From: Waters, David [David.Waters@pgnmail.com]
Sent: Wednesday, July 18, 2012 12:08 PM
To: Habib, Donald
Subject: Redline-Strikeout Version of QAPD
Attachments: Part 11 QAPD DRAFT_RL_SO.pdf

NGGM-PM-0033

Title: New Nuclear Plant Development Quality Assurance Program
Description Topical Report

Title: Progress Energy New Nuclear Plant Quality Assurance Program Description Topical Report

Figure II.1-1

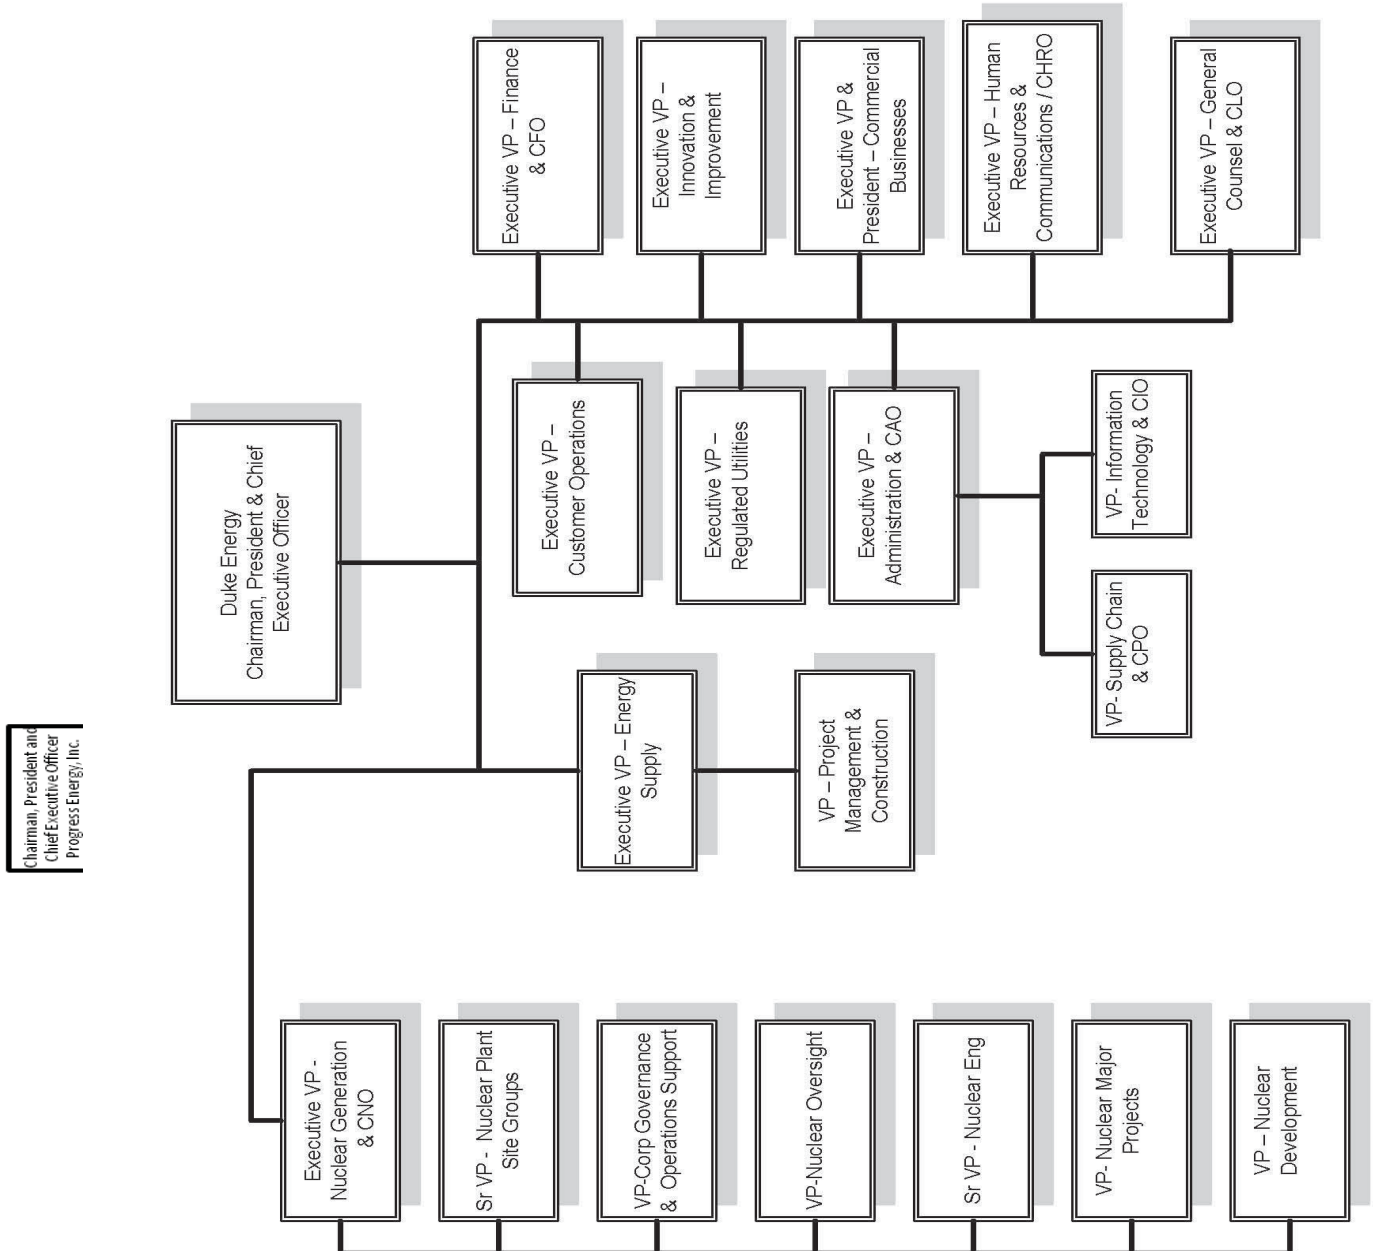
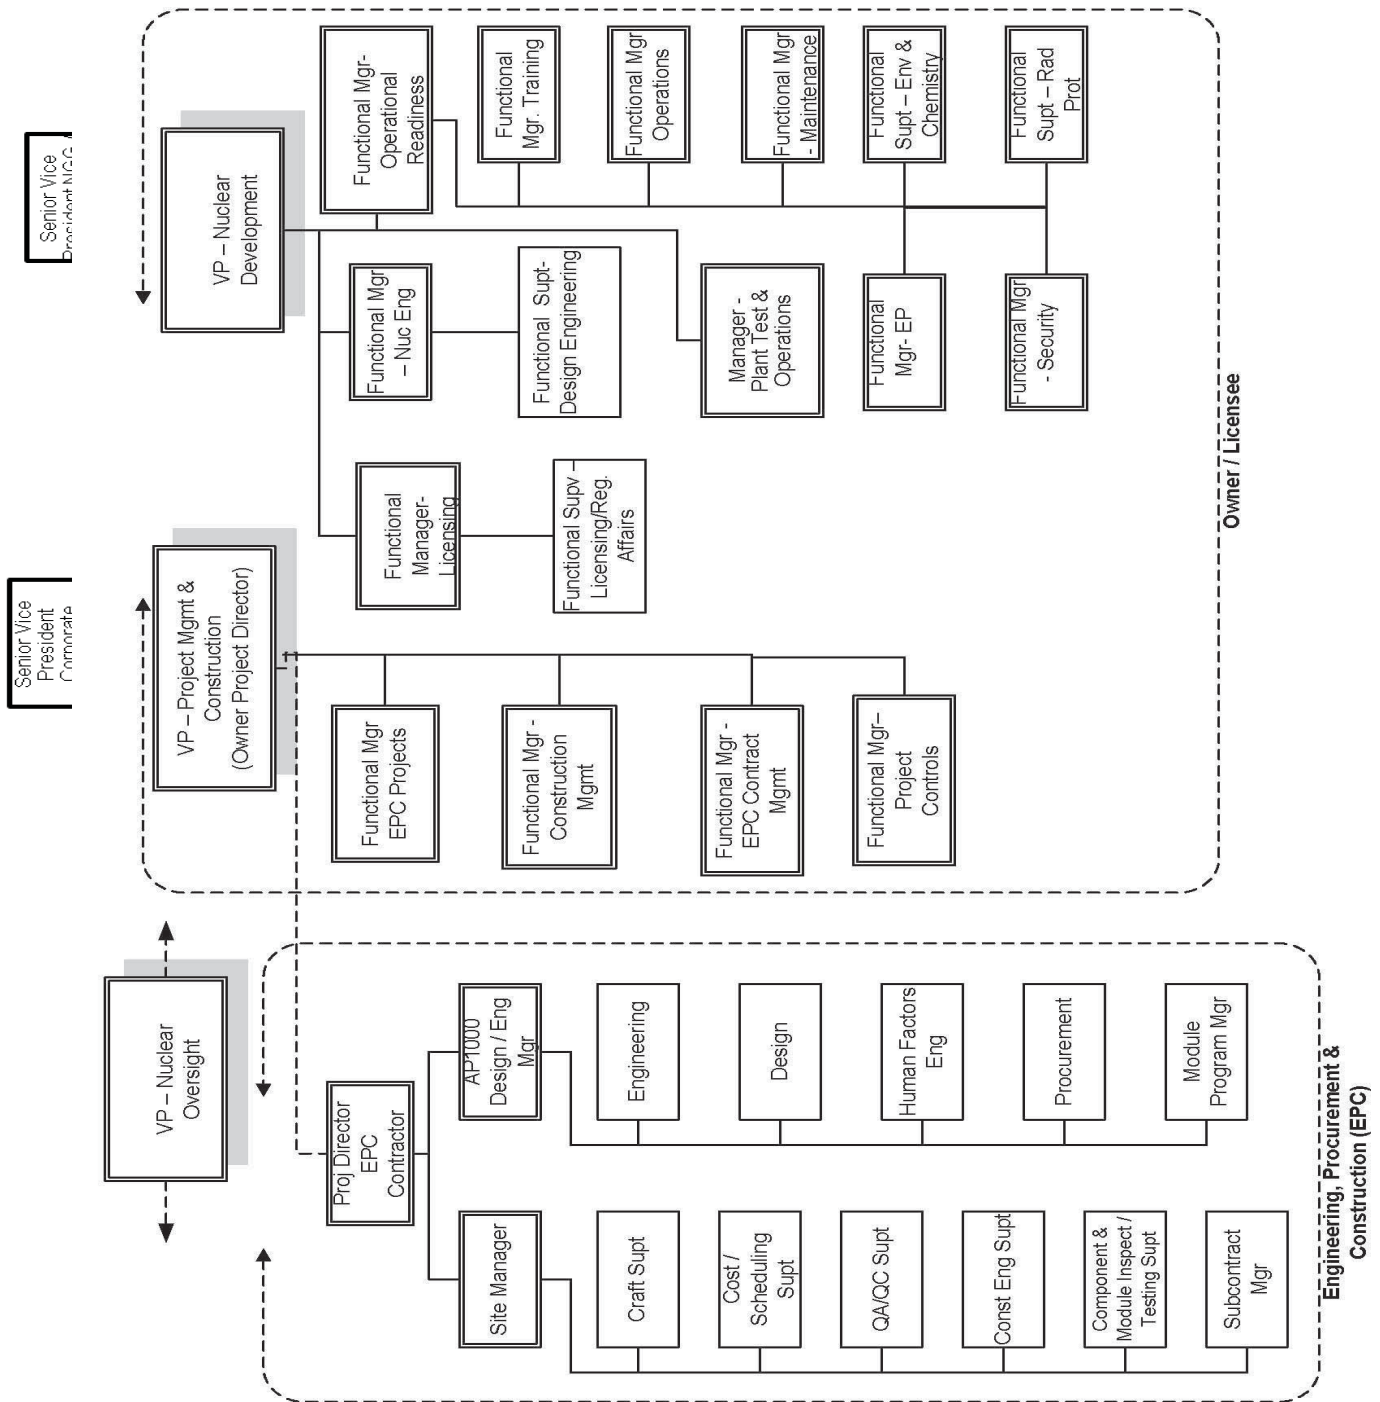
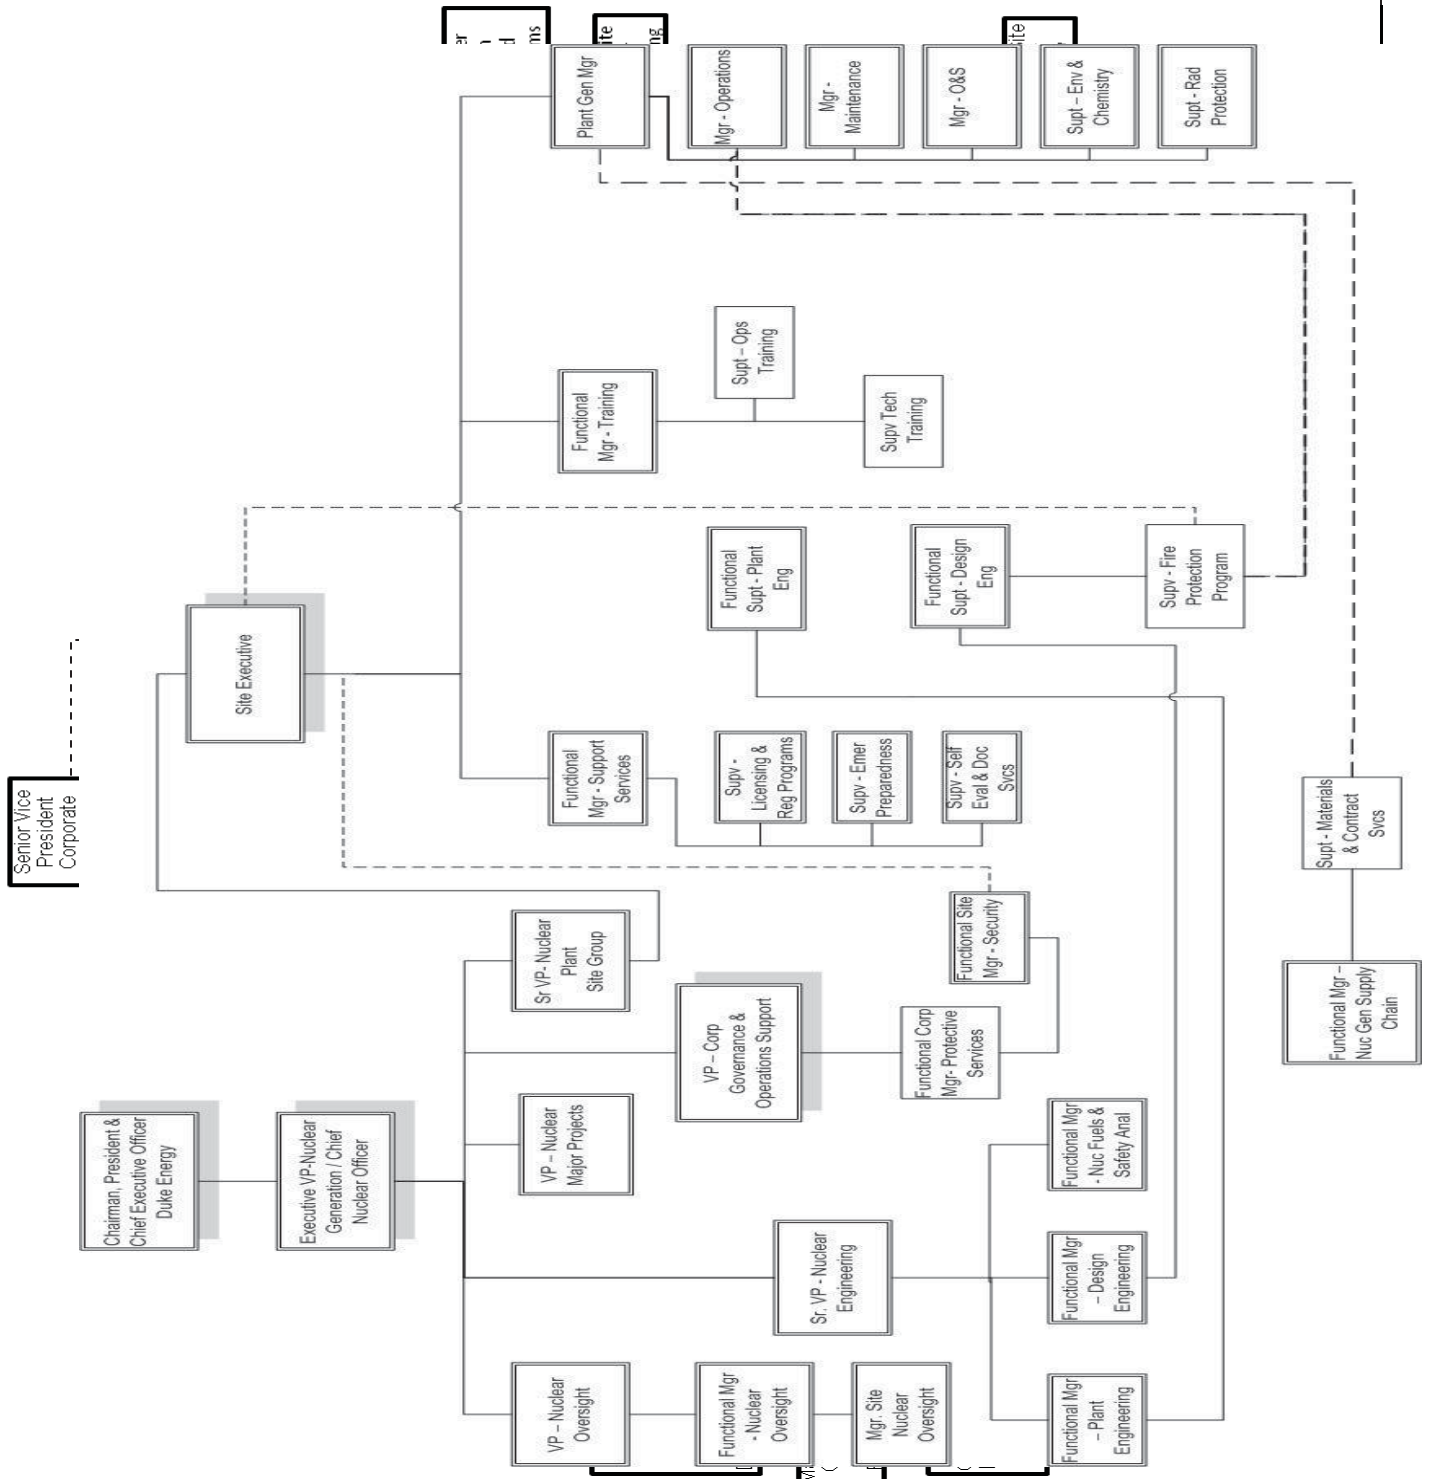
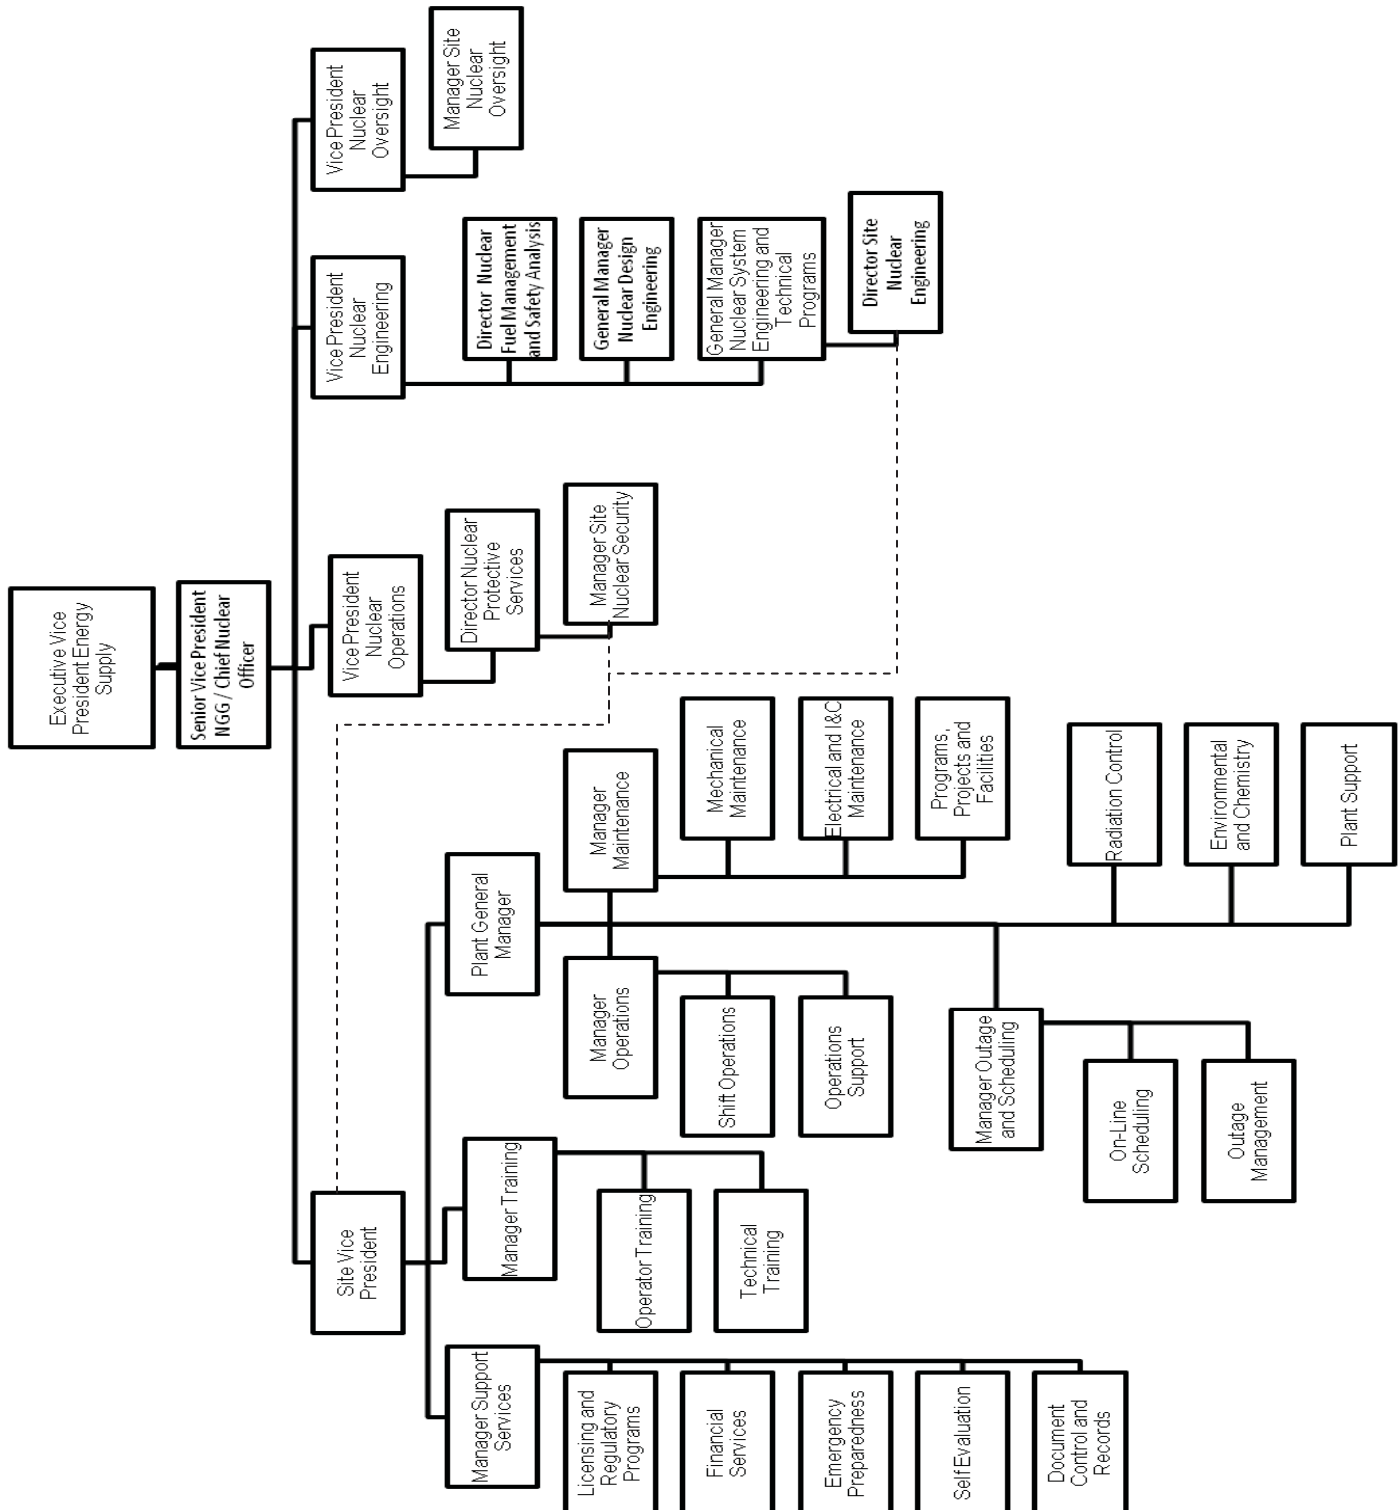
- Part II, Section 1.5 – 1.10 – Changed section numbering to reflect changes in section. No changes in section descriptions.
- Part II, Figures II.1-1, II.1-2, and II.1-3 – Revised figure to reflect new organizational structure and titles.
